## FORD 5R110W "Torqshift"

### INTERNAL HARNESS OR SOLENOID BODY SERVICE

Figure 1

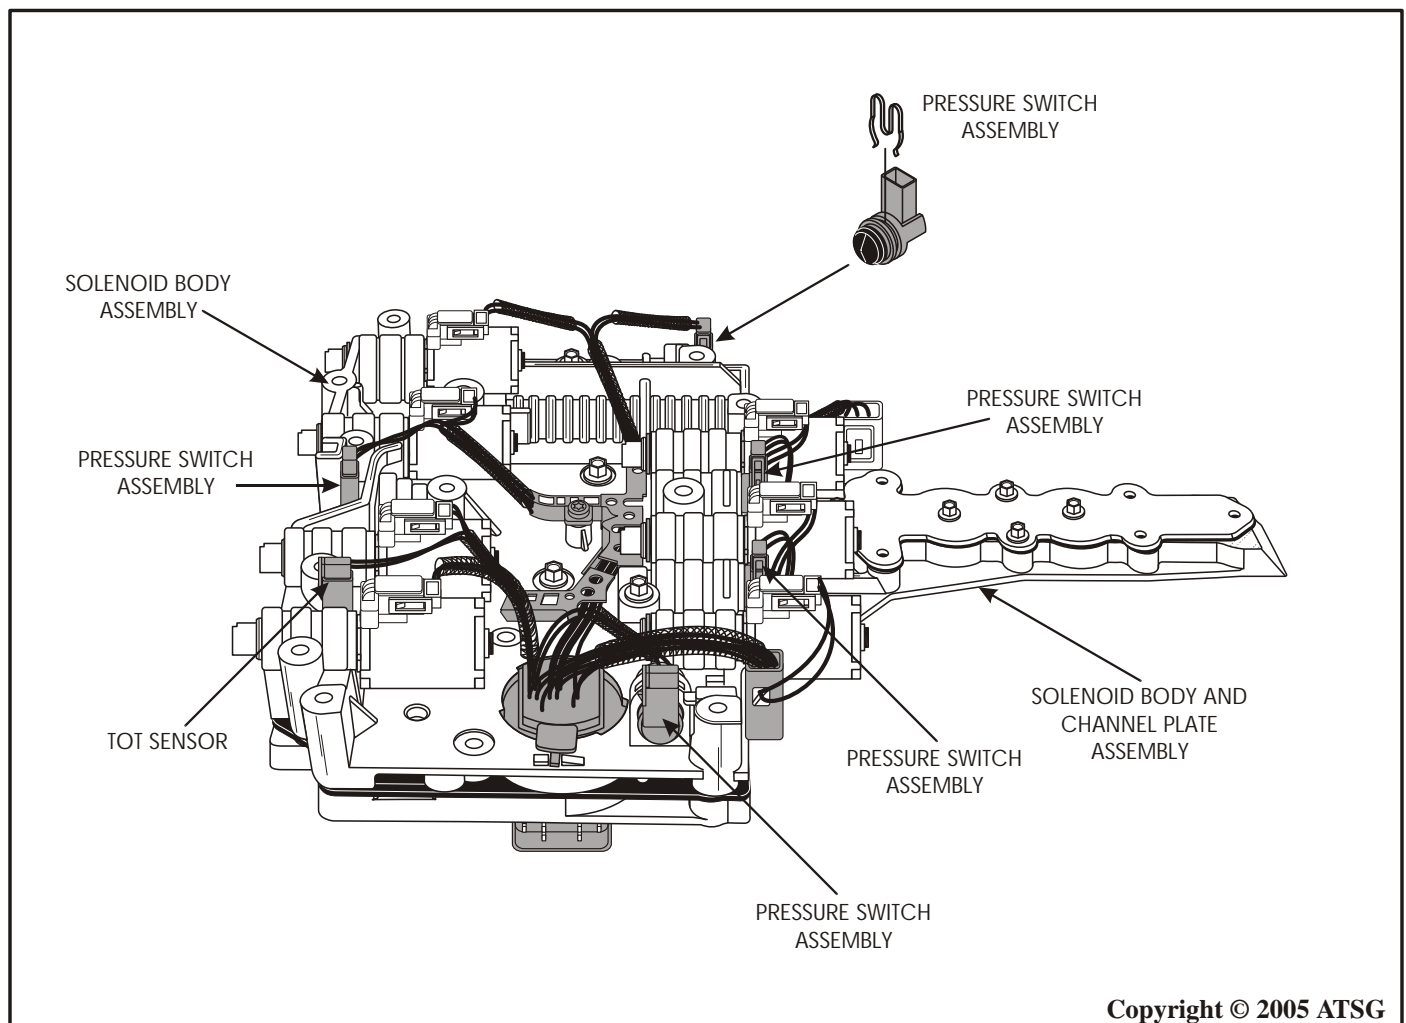
1. You may have to install a new service harness, without pressure switch connectors, into a unit that has pressure switches in the solenoid body. (See Figure 1 for locations)
2. You may have to install a new service solenoid body, without pressure switches, into a unit that has the original internal harness with pressure switch connectors. (See Figure 1 for locations)

**Note:** *These are both acceptable repairs and will not affect the function or operation of the transmission. Use of the pressure switch input was dropped from the vehicle calibration before the 2003 model year went into production.*
